July 7, 1982

Three Mile Island Nuclear Station, Unit 1 (TMI-1)
Operating License No. DPR-50
Docket No. 50-289
Emergency Feedwater System - Seismic

Enclosure 1

FIG. 1 TMI-1 EFW SYSTEM

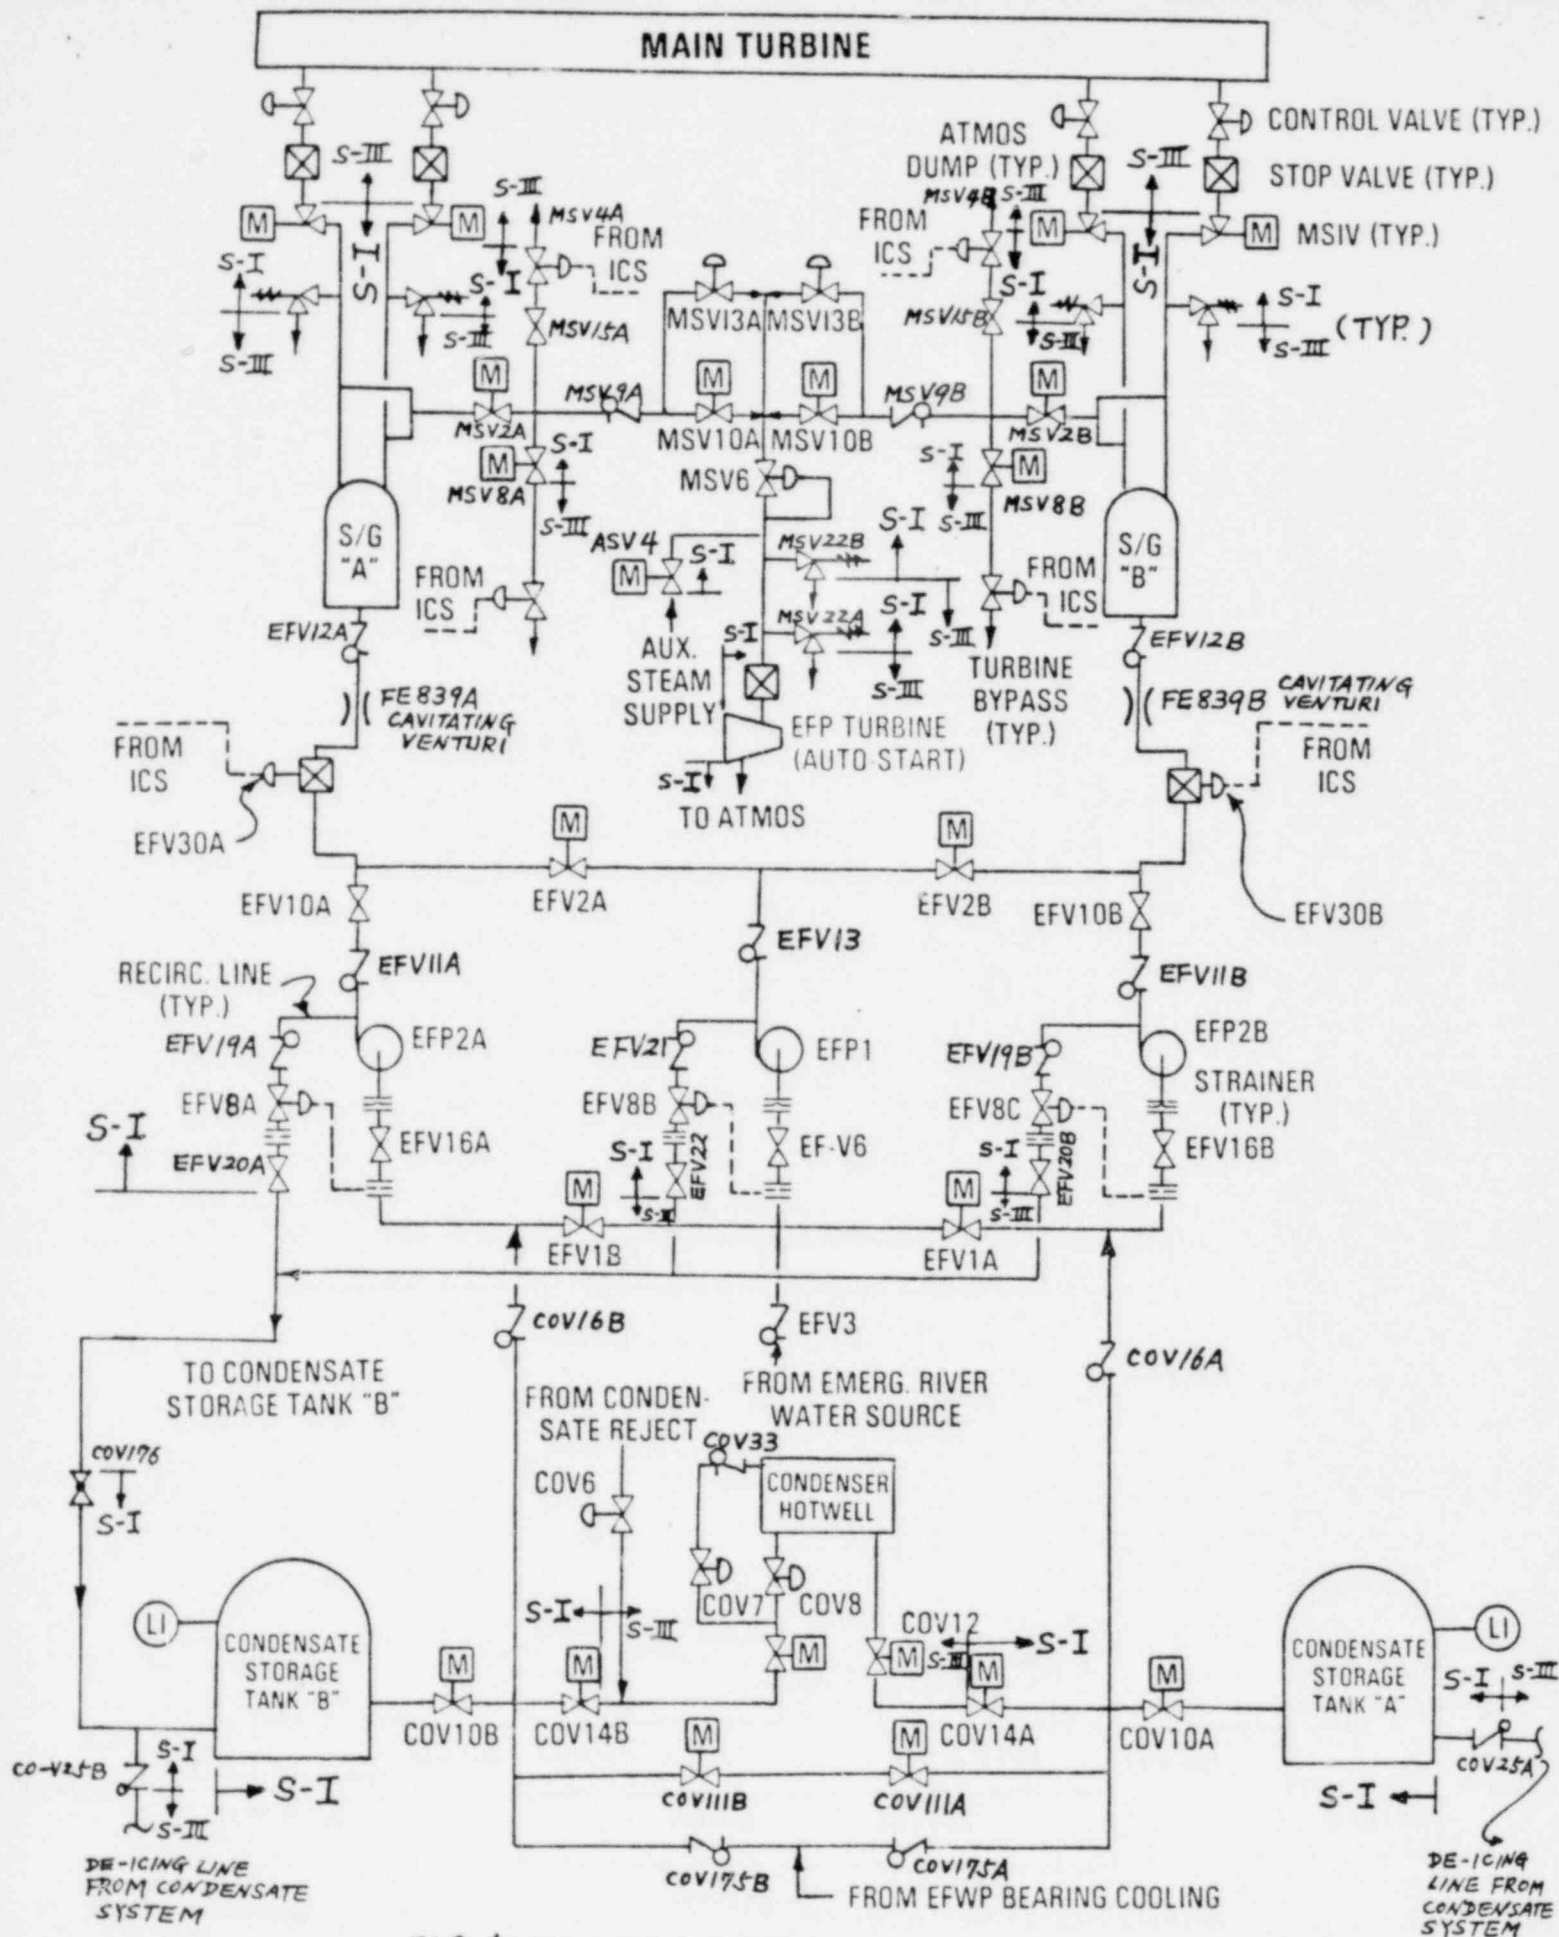
Clarify the extent to which your emergency feedwater (EFW) system boundary, considered in your December 8, 1981 response letter, coincides with the boundary defined in GL 81-14, especially parts (a) and (b) above.

The seismic boundary for the EFW System is indicated in the attached figures:

Figure 1 - TMI-1 EFW System

Further, the seismic break points for the attached figures 1 and 2 have been analyzed for three directional seismic restraints after each transition. All indicated seismic breaks have three directional support after the class change.

Branch lines one inch size and smaller (vents and drains) of the Emergency Feedwater System piping which are within the Seismic I boundary of the main piping system and whose seismic classification is indicated on drawings (302-081 and 302-101 in TMI-1 Restart Report) have not been evaluated as part of our response to IEB 79-14. Note that the vent stacks for the main steam safeties and the atmospheric dump valves are not Seismic I. The vent stack for the main steam safeties is judged to be adequate for seismic events. The stack for the atmospheric dump valves is still under evaluation. Results will be provided in September, 1982.

SKETCH NO. 1

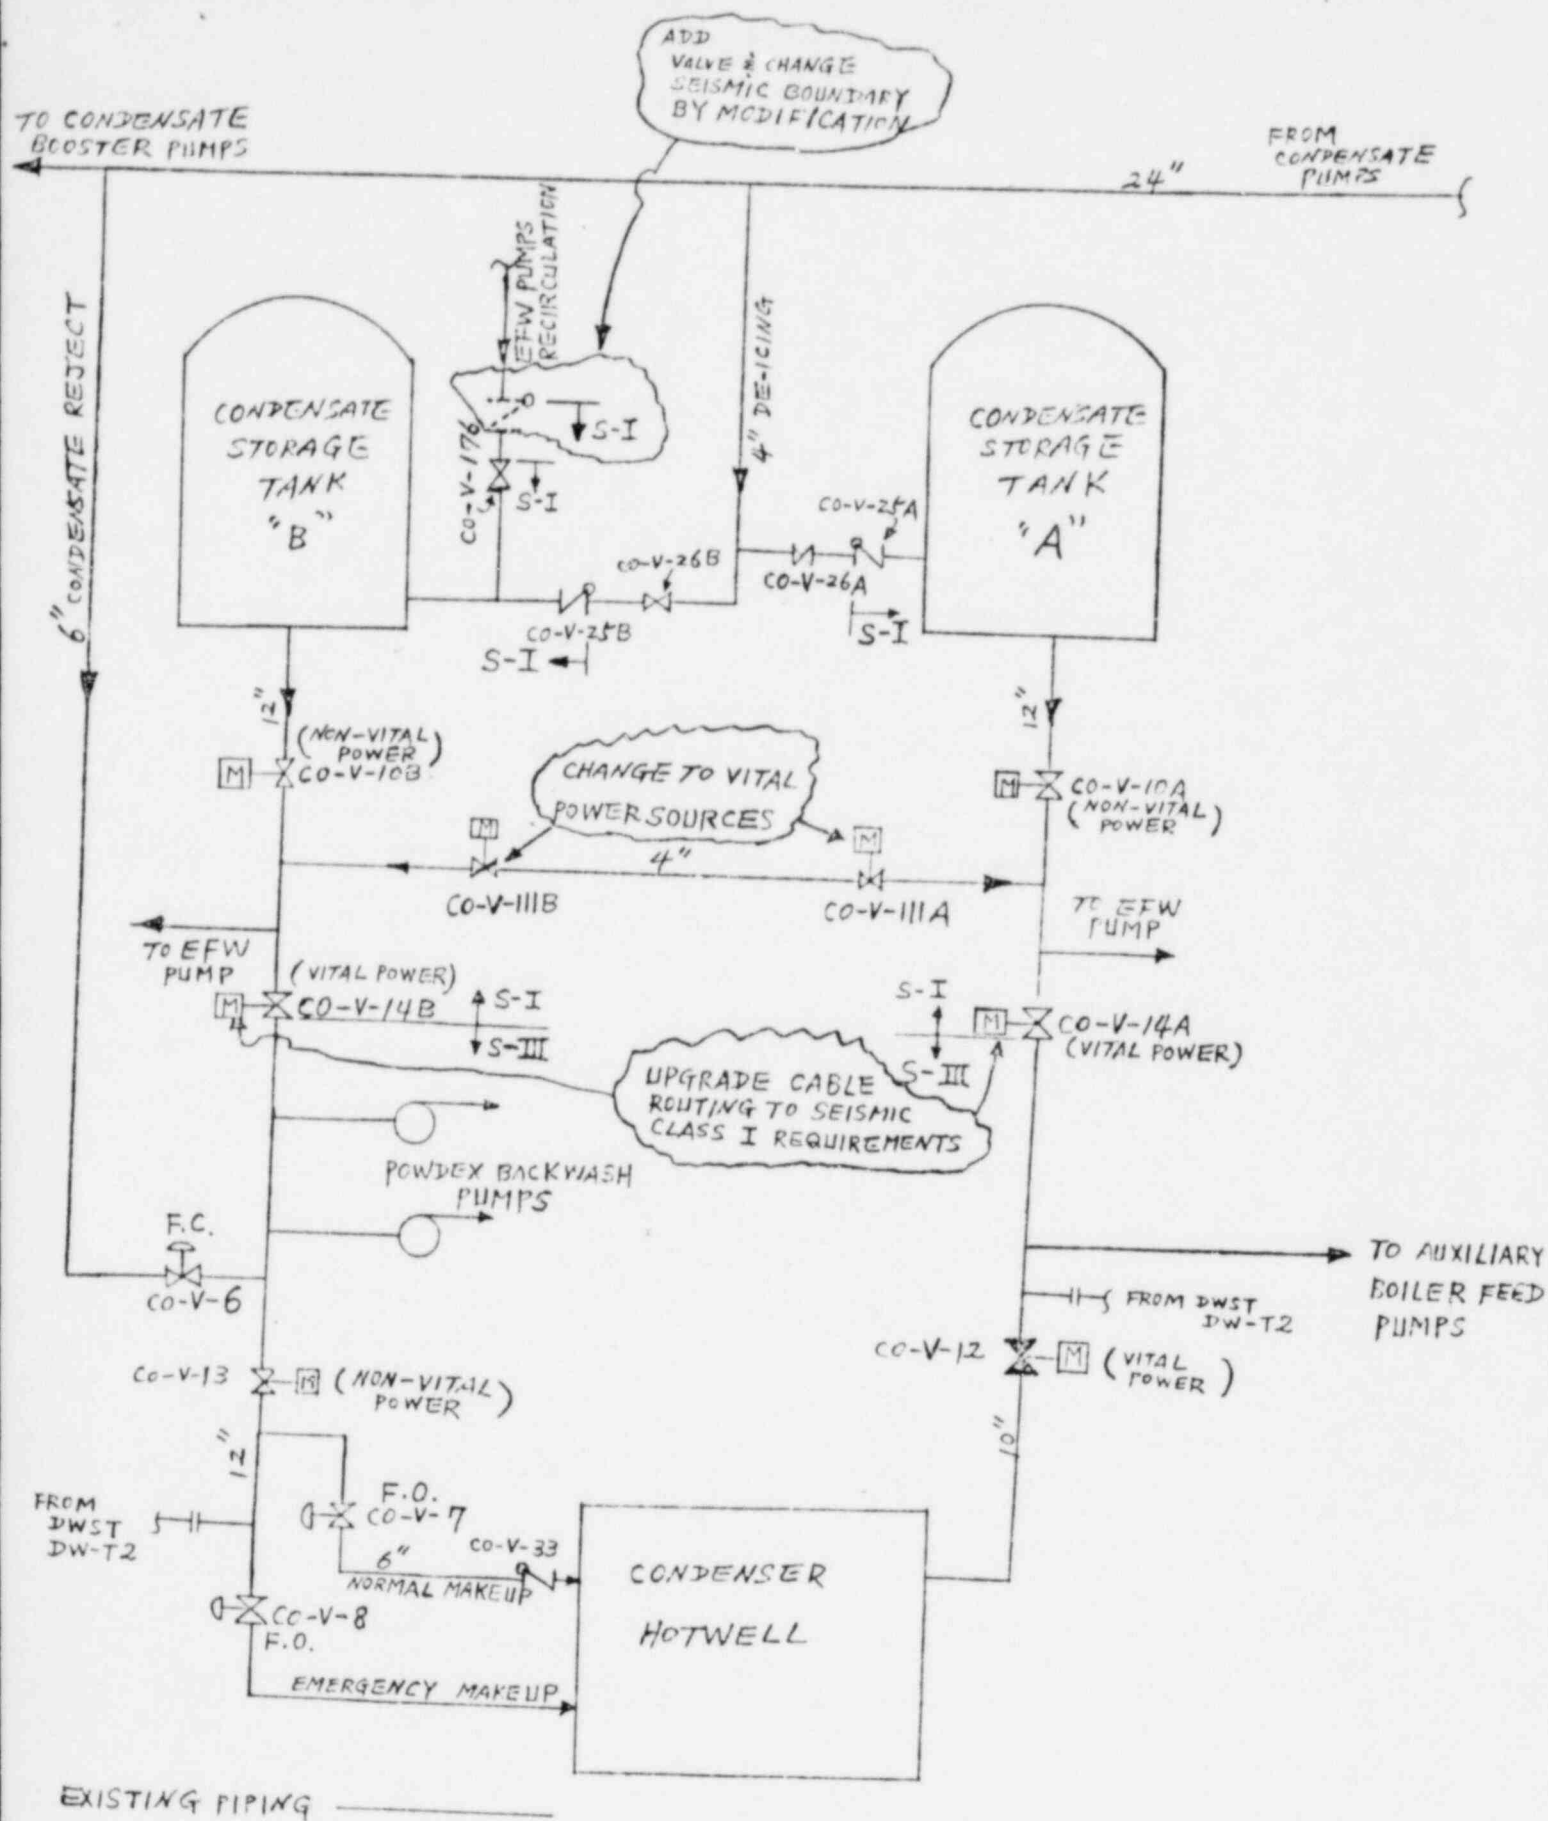
This evaluation concludes that modifications to the condensate system piping as shown on Sketch No. 1 and changes of operating procedures are required in order to achieve a safety grade condensate supply to the Emergency Feedwater System. These changes will be implemented prior to startup from the next (Cycle No. 6) refueling.

1. A new check valve should be installed in the EFW pumps recirculation line to the CST "B". This check valve should be installed as close as possible to the CST "B" in order to establish a seismic class boundary for the CST. (This will not be necessary if the EFW Pump recirculation line is upgraded to Seismic I criteria.) (See Met Ed letter, 9/29/81, L1L 269)

- A. Add a check valve in the EFW pumps recirculation line and change the Seismic Class I boundary as shown on the attached sketch.

This new check valve should be installed as close as possible to the CST "B" so that it will prevent the loss of water from CST "B" in the event of a line break in the non-seismic portion of the recirculation line.
